Re: Building Permit No: B-16003304  
12942 Brighton Dam Road  
Updated Plot Plan

Please accept this revised plot plan to accompany building permit number B-16003304

### STORMWATER MANAGEMENT PLAN

#### KURICHH PROPERTY

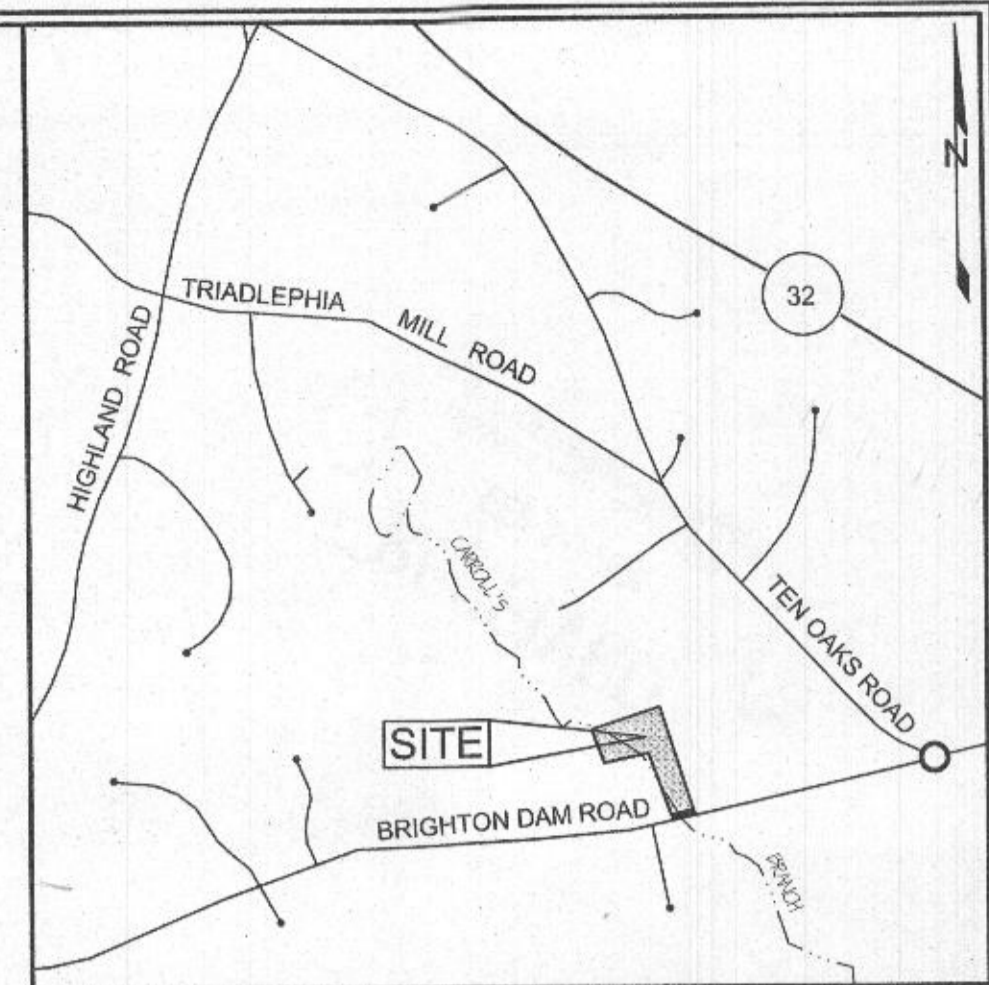
The Health Department has requested a revision the septic design. This plan shows the revised septic system design that moves the location of the proposed septic tanks. The two (2) of the proposed drywells designed to treat stormwater have been removed due to the change. The remaining five (5) drywells have increased in size to meet the required treatment. Revised SWM calculations are attached.

REVISED  
Date: 2/13/18  
Comments: B16003304  
Revised SWM, Relocated Septic
